Approved for access by the Solid Waste Department.

SKYVIEW WEST INDUSTRIAL
FOR BRUNACINI DEVELOPMENT
7226 CENTRAL AVE., SW
ALBUQUERQUE, NEW MEXICO

SITE DEVELOPMENT
PLAN

SDP-1

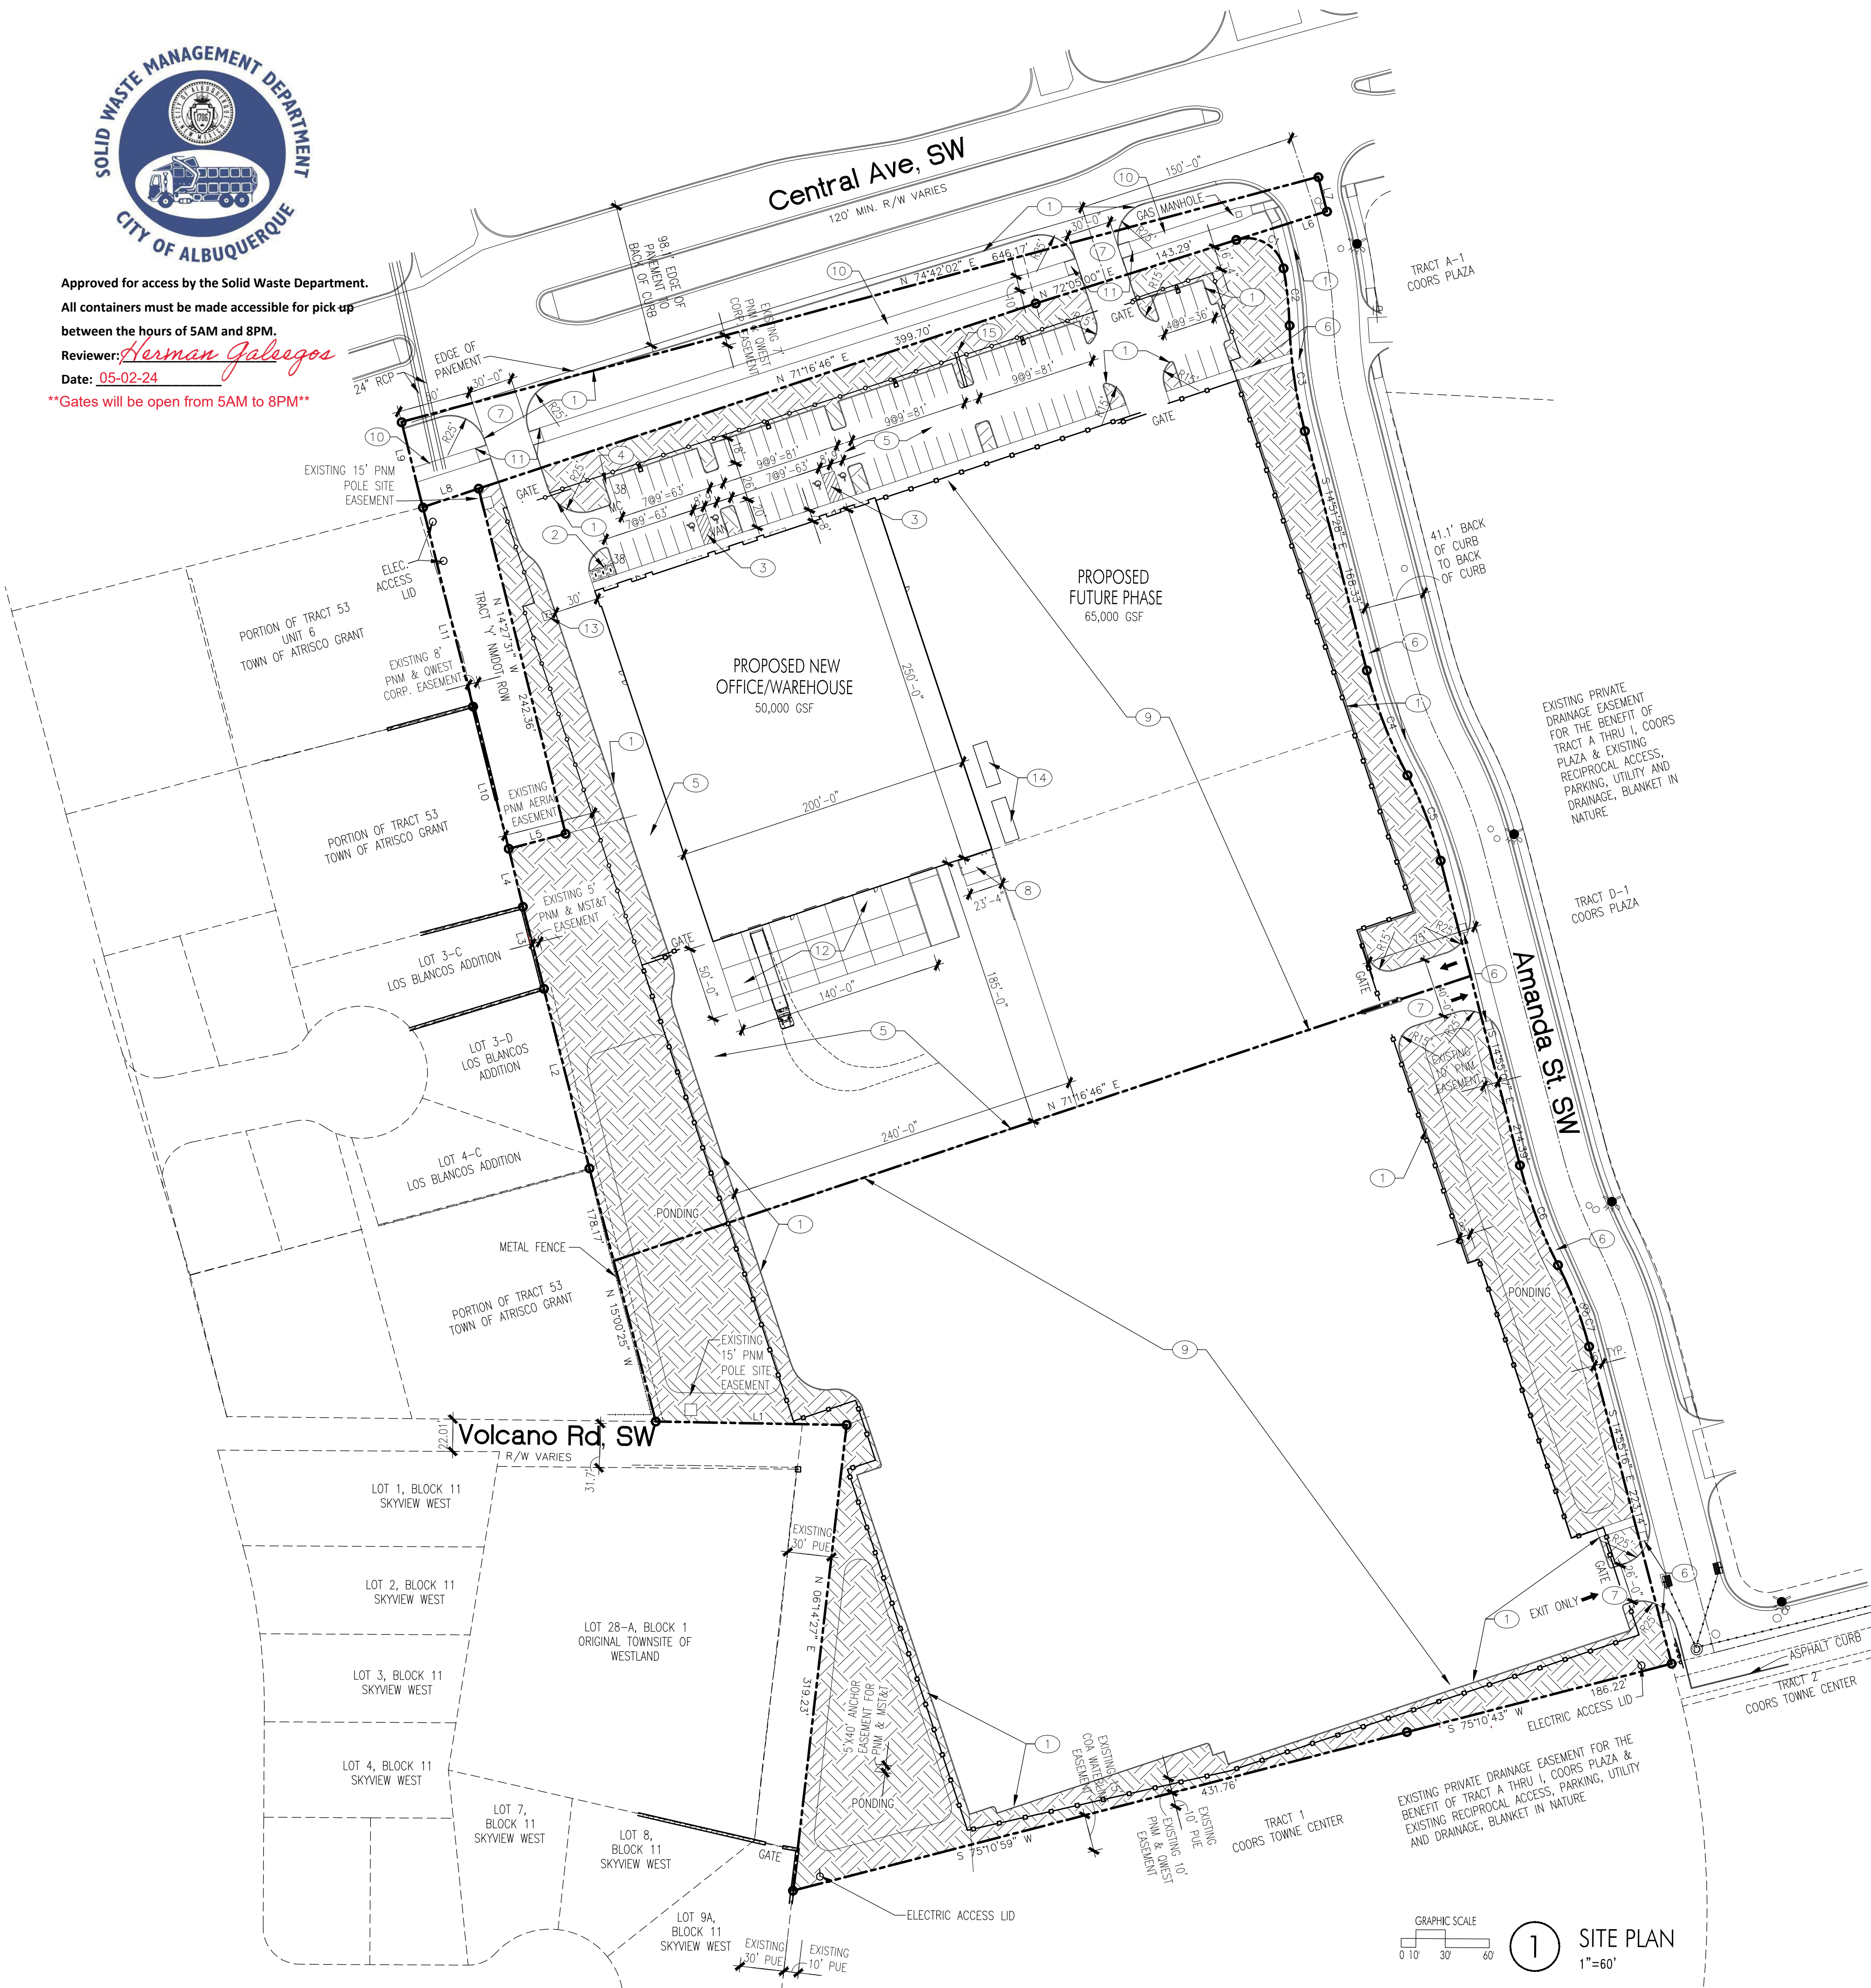
All containers must be made accessible for pick up between the hours of 5AM and 8PM.

Gates will be open from 5AM to 8PM
